Question 2/15

STUDY GROUP 15 - CONTRIBUTION

SOURCE* : France Telecom
TITLE: Proposal for amendment of H310, H32x DRAFT RECOMMENDATIONS

Figure 1: Internetworking of terminals between B-ISDN & N-ISDN

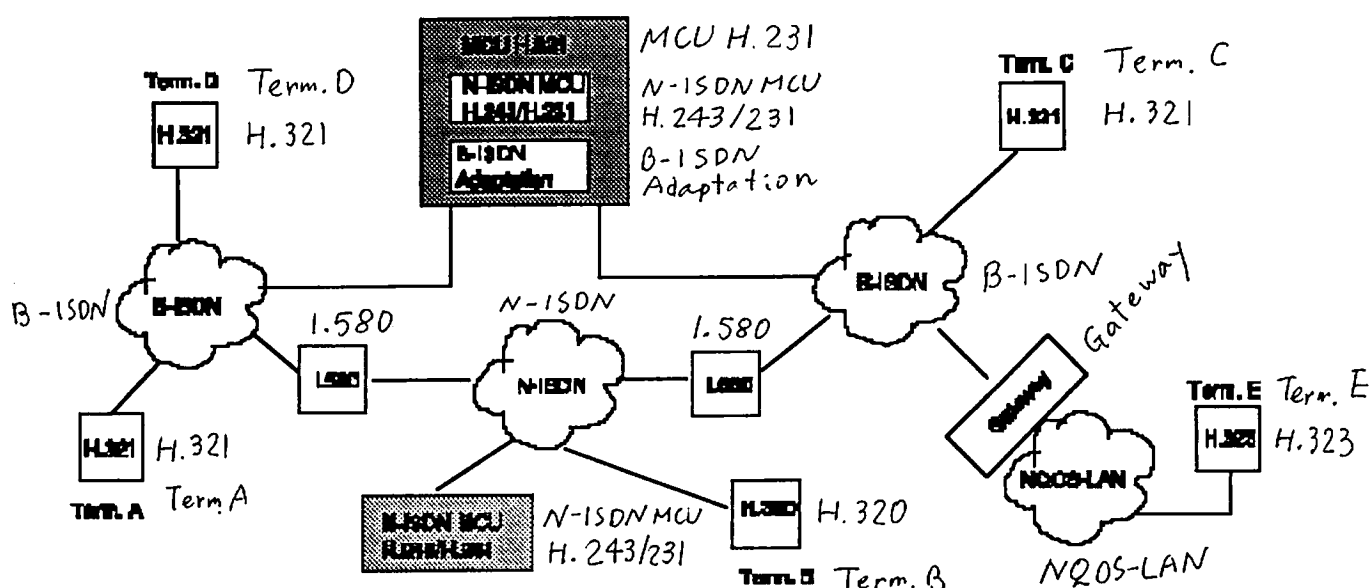
These documents are focusing on the N-ISDN connections but take into account a possible connection from a B-ISDN terminal calling this multipoint. (see fig. 1).

For this reason, H.231 states that the bitrate of a MCU communication has to be the same for all primary terminals. H.243 states also that all terminals must synchronize their receiving and sending clock on the MCU unit clock.

Since all kinds of intercommunications through different networks should be possible some configuration could affect the correct working of the service.

A possible way of implementing synchronisation is to use some control mechanism for cases where it is compulsory such as for multipoint conference. These means might be provided via in-band signalling or via network signalling. For the time being, it is proposed that terminals should be designed to work in a synchronised way.

In order to allow the interworking of current MCUs with ATM and LAN endpoints, some means are to be provided to synchronise the various bit rates for audio and video. For the time being, it is proposed that the H310, H32x recommendations under approval are amended to request that terminals should be designed to work in a synchronised way. In a second step, it is proposed to clarify synchronization mechanisms in order to define to which clock the mastership should be allocated.
